REMEDIATION SYSTEM EVALUATION

DELPHI CORPORATION
VANDALIA, OHIO

Report of the Remediation System Evaluation,
Site Visit Conducted at the Delphi Corporation, Vandalia, Ohio Facility
March 6, 2003

EPA 542-F-04-023
June 2003
www.epa.gov/tio
clu-in.org/optimization

FIGURE 1-3. TCE DISTRIBUTION IN THE TOP OF ROCK

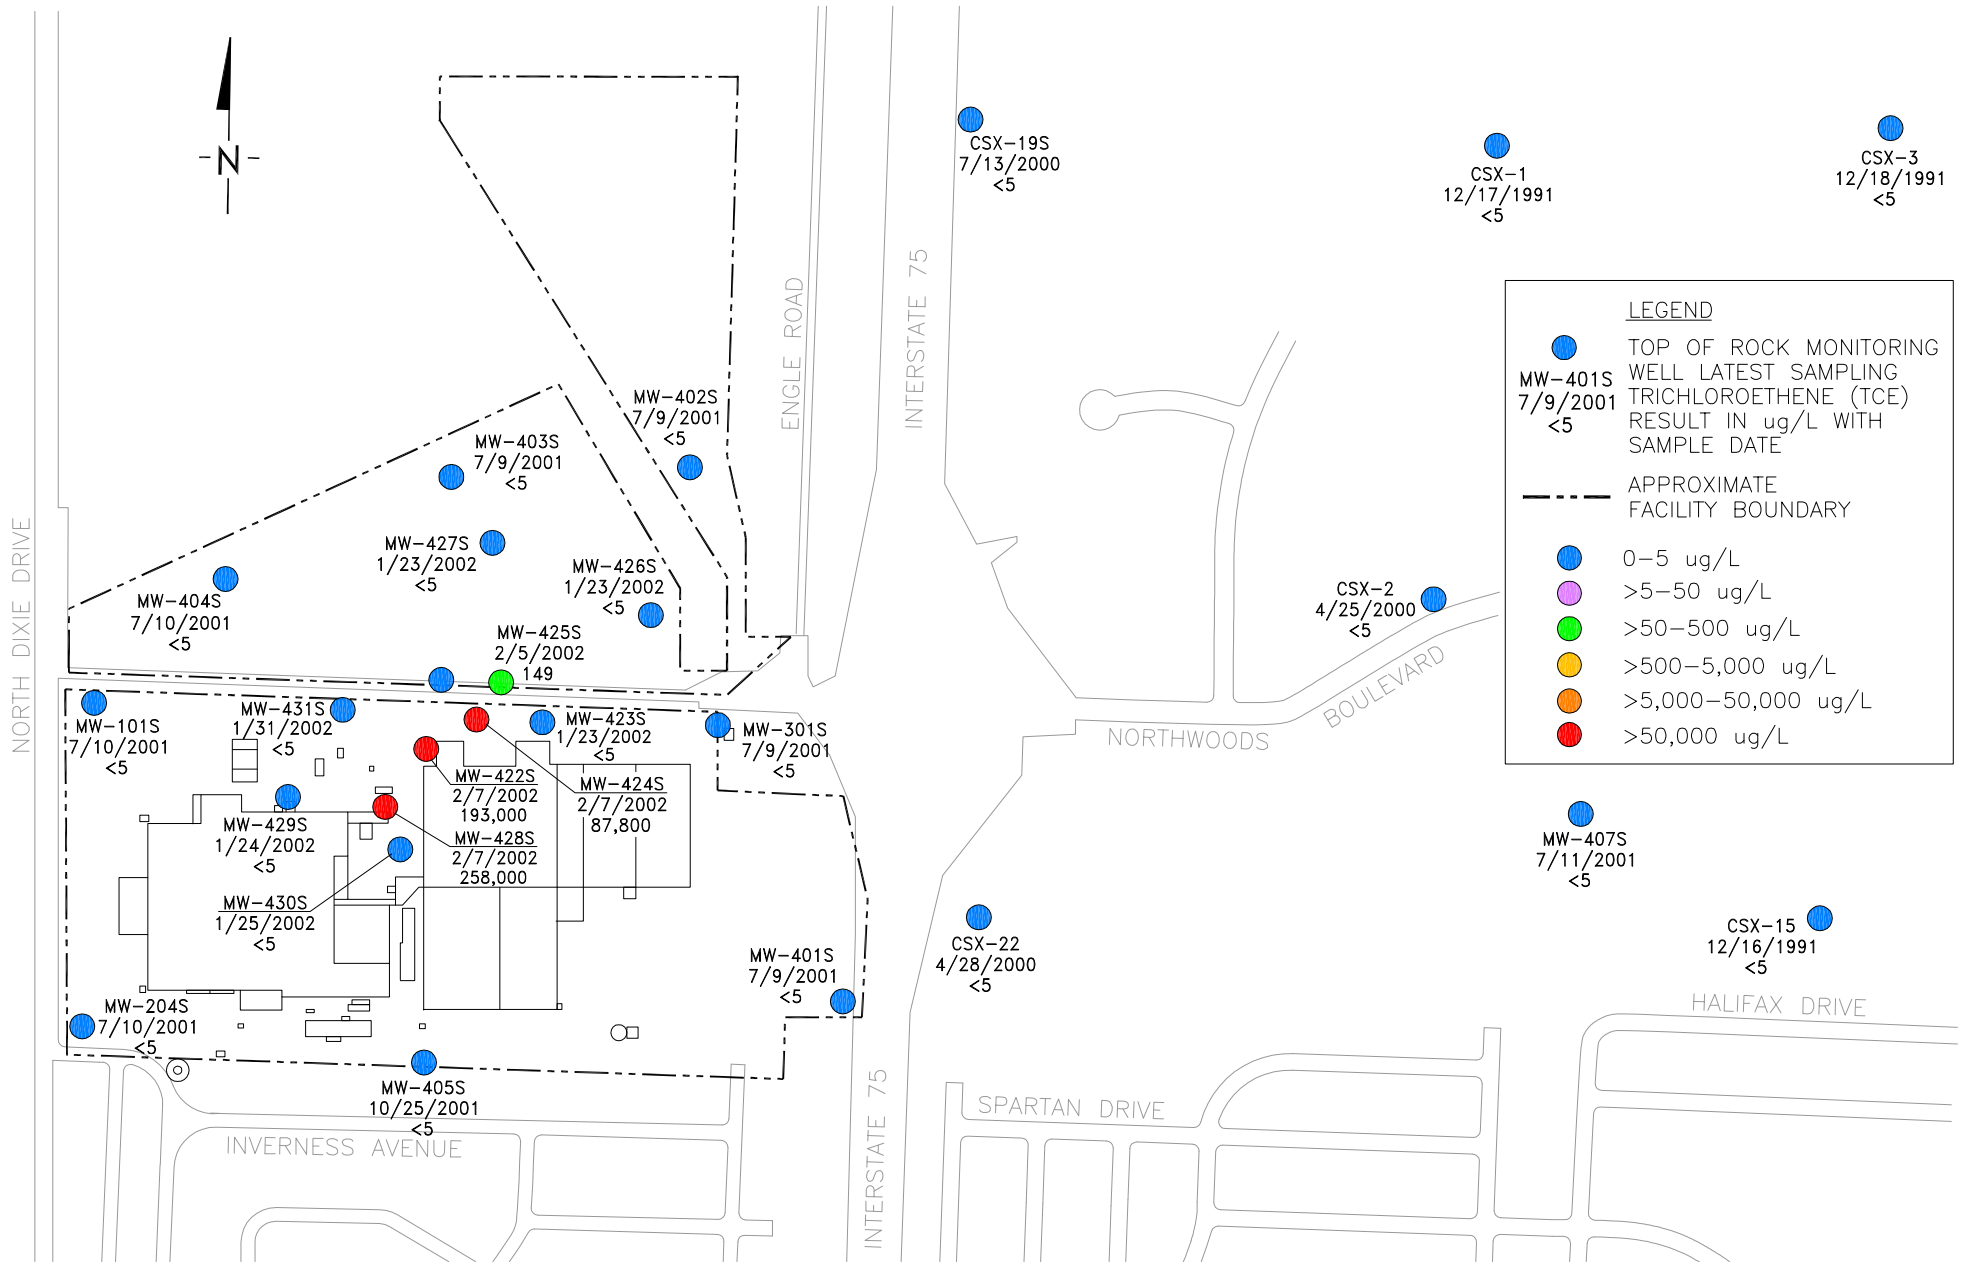
Dissolved ground water contamination in the Top of Rock zone (see Figure 1-3) appears to be controlled by a piezometric low near MW-424S (see Section 4.2.1 and 4.2.2 of this report) where water in the Top of Rock appears to discharge to the underlying Sugar Rock. Wells upgradient of this area historically have elevated TCE concentrations. For example, in the fourth quarter of 2002, MW-422S had a TCE concentration of 200,000 ug/L. Wells downgradient of this area (MW-423S, MW-445S, MW-446S, and others) have undetectable TCE concentrations. Although this piezometric low appears to capture site-related contamination within the Top of Rock aquifer, one supply well at a property located on Engle Road, located just north of the facility, has detectable concentrations of TCE that are below the MCLs. However, that well on Engle Road has an open intake that extends from the Top of Rock to the Sugar Rock, so the contamination at that well is likely drawn from the Sugar Rock.

In the Top of Rock, there is no intended target capture zone and no implemented remedy because contaminated water appears to be naturally contained by the discharge of water to the underlying Sugar Rock. As shown in Figure 1-3, ground water sampling and analysis in the Top of Rock suggests that VOC contamination above MCLs is limited to four wells in the north central portion of the property (MW-422S, MW-424S, MW-425S, and MW-428S). The sampling results from other monitoring wells in the Top of Rock and interpretation of capture from the potentiometric surface map suggest that the contamination in these wells is contained horizontally. The only indications of potential TCE or cis-1,2-DCE contamination in the Top of Rock that is likely outside of the capture zone are the sampling results from 10591 Engle Road, which is approximately 500 feet to the northeast of the facility and near the Unnamed Tributary. The concentrations at this location are below MCLs and all other wells in the area (both monitoring and supply wells) have no detectable concentrations of these constituents. This well is constructed with an open interval that extends from the Top of Rock to the Sugar Rock and it is likely that TCE in this well is related to the Sugar Rock.

FIGURE 1-4. TCE DISTRIBUTION IN THE SUGAR ROCK, FIRST QUARTER 2003

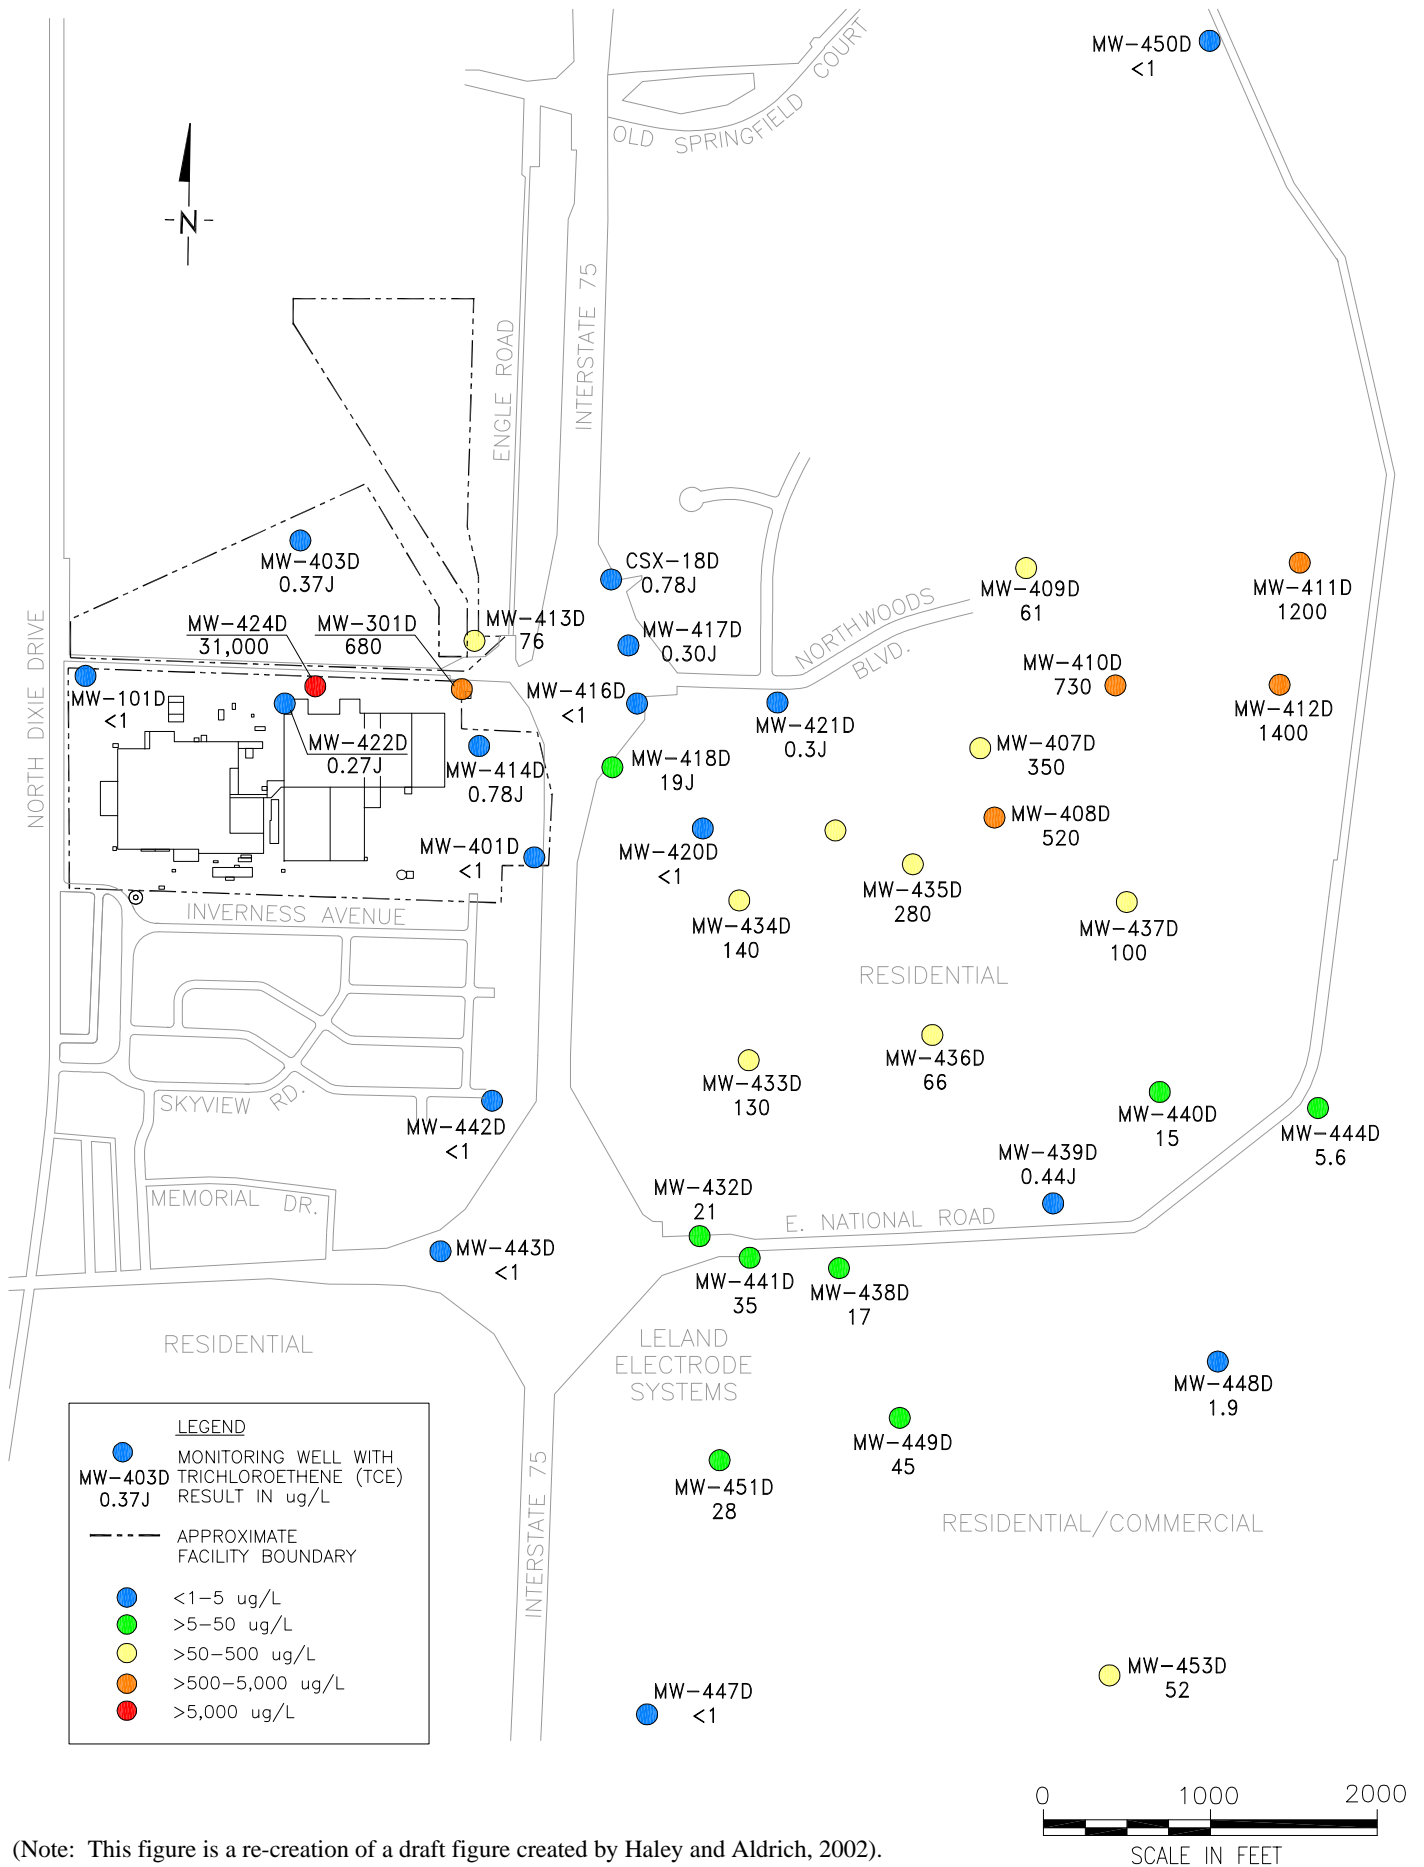
Ground water contamination in the Sugar Rock extends over a mile from the site to the east. The highest concentration in this unit is repeatedly detected at MW-424D (see Figure 1-4 for location), which is located in the area where TCE impacted water from the Top of Rock zone is suspected to enter the Sugar Rock through an old production well boring. During the fourth quarter of 2002, MW-424D had a TCE concentration of 30,000 ug/L. Elevated concentrations of cis-1,2-DCE and 1,1 DCA were also detected (5,000 ug/L cis-1,2-DCE and 290 ug/L 1,1 DCA). Concentrations offsite to the east decrease near P-301, which is the extraction well for the ground water migration control system, and then increase again approximately 3,000 feet from the facility. In the first quarter of 2003, the TCE concentrations along Cassel Road were over 1,000 ug/L (1,200 ug/L in MW-411D and 1,400 ug/L in MW-412D). Beyond these points ground water discharge through seeps to surface water that eventually empties into the Great Miami River.

FIGURE 4-1. POTENTIOMETRIC SURFACE MAP FOR THE TOP OF ROCK, JULY 2002

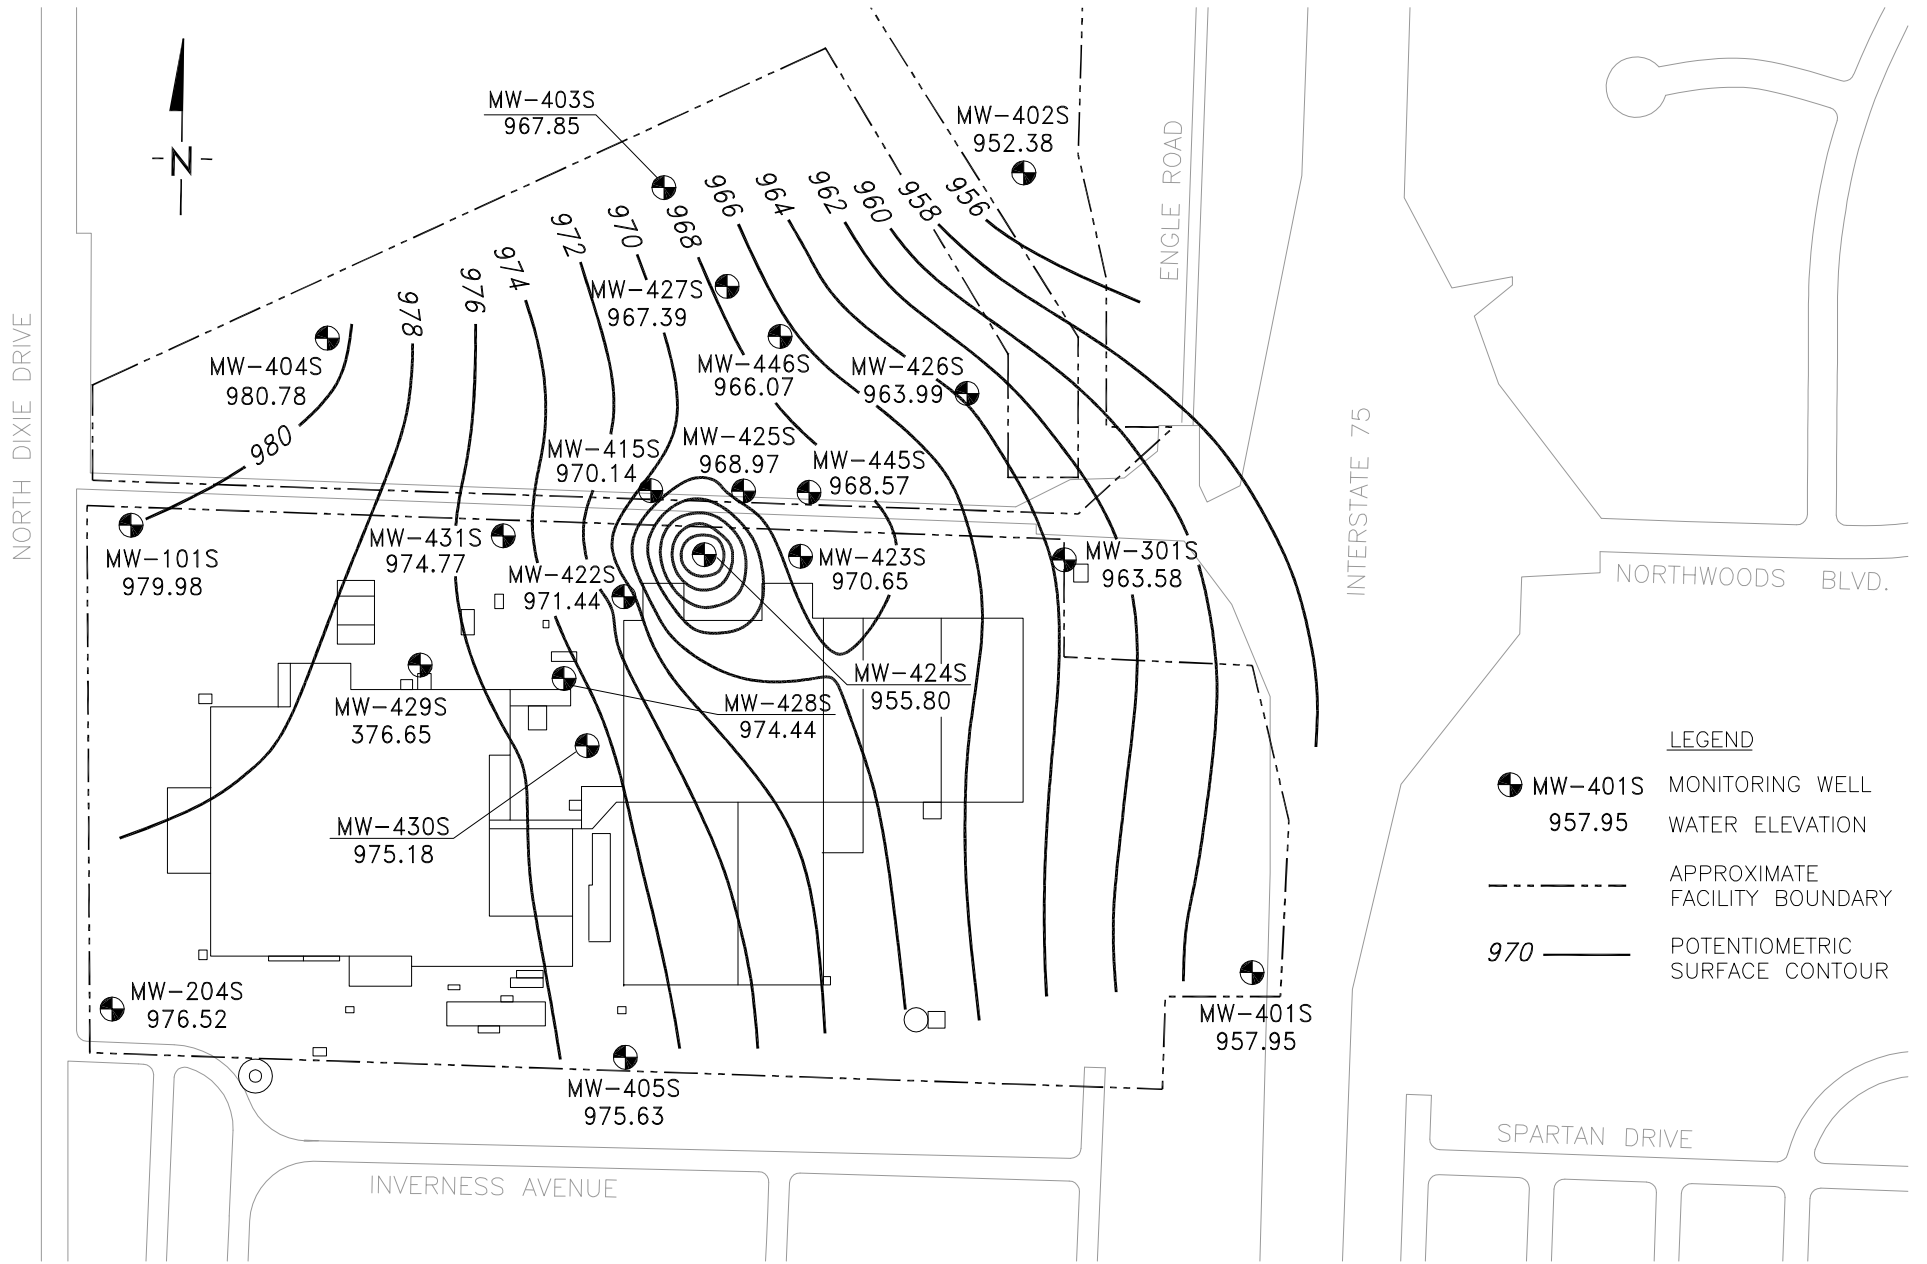
Water levels from the Top of Rock are collected quarterly and corresponding potentiometric maps are generated. Figures 4-1 depicts a typical potentiometric surface map for the Top of Rock unit. The regional water elevation ranges from approximately 980 feet above mean sea level (MSL) at the western property boundary to approximately 960 feet MSL at the eastern property boundary. A localized low in the water table is present at MW-424S where the water level is approximately 956 feet MSL. This low likely represents an area where water from the Top of Rock discharges to the Sugar Rock.
